Re: Supplemental Submission

Applicants' Response to Comments from July 8, 2020, Public Hearing
Sudbury-Hudson Transmission Reliability and Mass Central Rail Trail Project

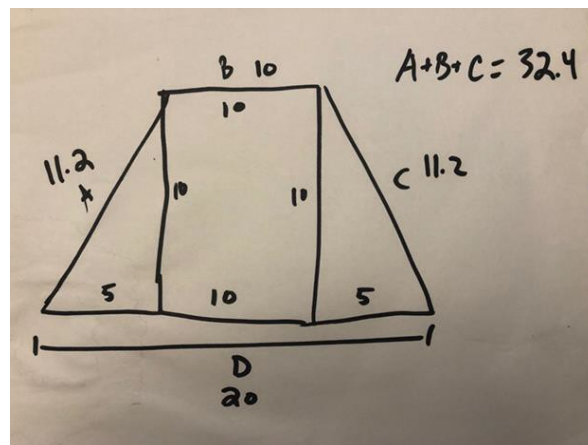
- 60. With multiple work crews coming from different sides of the ROW, is it possible to reduce the width of the 19-foot construction platform that provides for two way construction traffic?**

No, having multiple crews come from different sides of the ROW would not allow for reduction of the construction platform width. Even if a public road-to-public road segment is broken into subsegments for different crews, there will be multiple vehicles travelling within that subsegment as work proceeds in a linear fashion from rail and tie removal to grading to manhole installation to duct bank installation to stabilization.
